SERVICE BULLETIN

75A-4

**SUBJECT: "S" METER SENSITIVITY POTENTIOMETER AND
ZERO POTENTIOMETER REPLACEMENT**

**DRAWING-INSTALLATION
5 METER-POT**

TOP VIEW OF FRONT PANEL

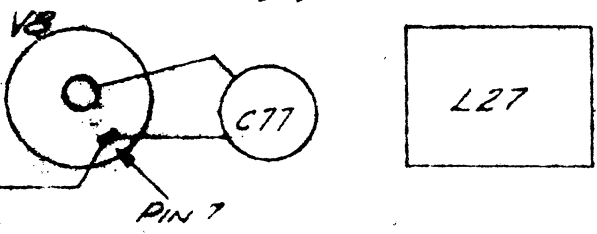
ADD THIS
DA9256 WIRE
TO CABLE

IT WILL BE NECESSARY TO DISCONNECT
DA9256 WIRE ON TERMINAL #3- & CONNECT
TO TERMINAL #4. (THIS WILL PUT 2
DA9256 WIRES ON TERMINAL #4.)

9. The meter should be wired as shown in the top view of the front panel on installation drawing 542 4452 002.
10. Rewire the terminal strip adjacent to tube V8 as shown in installation drawing 542 4452 002.

UNDER CHASSIS
VIEW

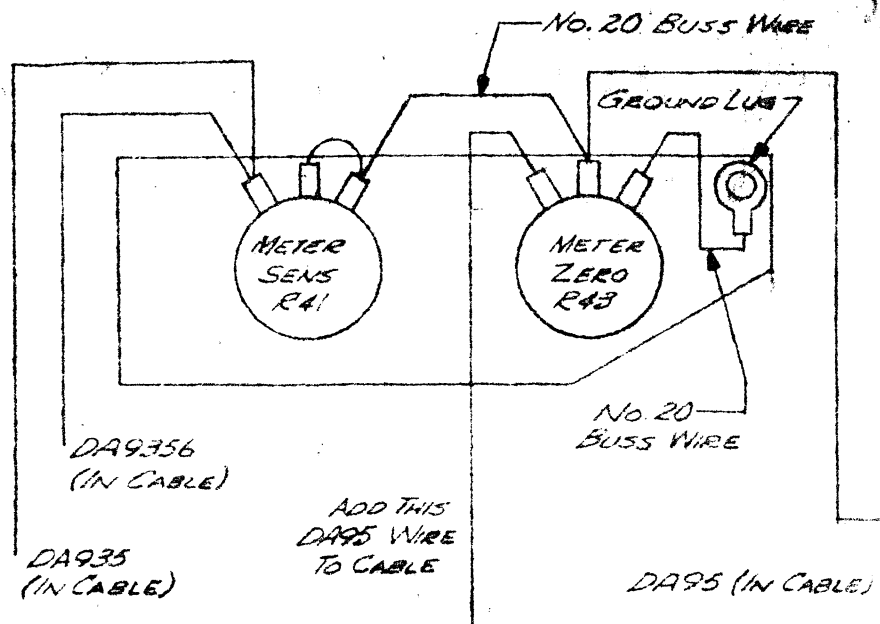
ADD NO. 20
BUSS WIRE
FROM TERMINAL
1 TO PIN 7
OF V8

10. REWIRE TERMINAL STRIP AS SHOWN.

9. METER SHOULD BE WIRED AS SHOWN IN TOP VIEW OF FRONT PANEL.
8. CONNECT DA9356 WIRE WHICH FORMERLY WENT TO HOT TERMINAL OF METER SENSITIVITY POT TO CLOCKWISE TERMINAL OF NEW METER SENSITIVITY POT.
7. REMOVE SHORT DA935 WIRE FROM CABLE WHICH CONNECTS METER ZERO POT TO METER SENSITIVITY POT.
6. DELETE R40 WHICH IS ACROSS METER.
5. MOVE R39.
4. REMOVE R42.
3. MOUNT POTS P/N 750 8071 00 TO PLATE P/N 542 3150 002 AND MOUNT ASSEMBLY TO SPACERS.
2. MOUNT 6-32 X 1-1/4 SPACERS (P/N 540 9225 003) IN HOLES FORMERLY USED FOR MOUNTING ZERO SET SENSITIVITY POTS.
1. REMOVE METER SENSITIVITY & METER ZERO POTS.

1. Remove Meter Sensitivity and Meter Zero potentiometers.
2. Mount 6-32 x 1¼ spacers (540 9225 003) in holes formerly used for mounting zero set and sensitivity potentiometers.

3. Mount potentiometers (750 8081 00) to plate (542 3150 002) and mount this assembly to the spacers.
4. Remove resistor R42.
5. Move resistor R39 as illustrated on installation drawing 542 4452 002.

6. Delete resistor R40 which shunts the meter.
7. Remove from the cable the short wire with orange and green tracers which connects the meter zero potentiometer to the meter sensitivity potentiometer.

8. Connect the wire with orange, green, and blue tracers which formerly went to the hot terminal of the meter sensitivity potentiometer to the clockwise terminal of the new meter sensitivity potentiometer.
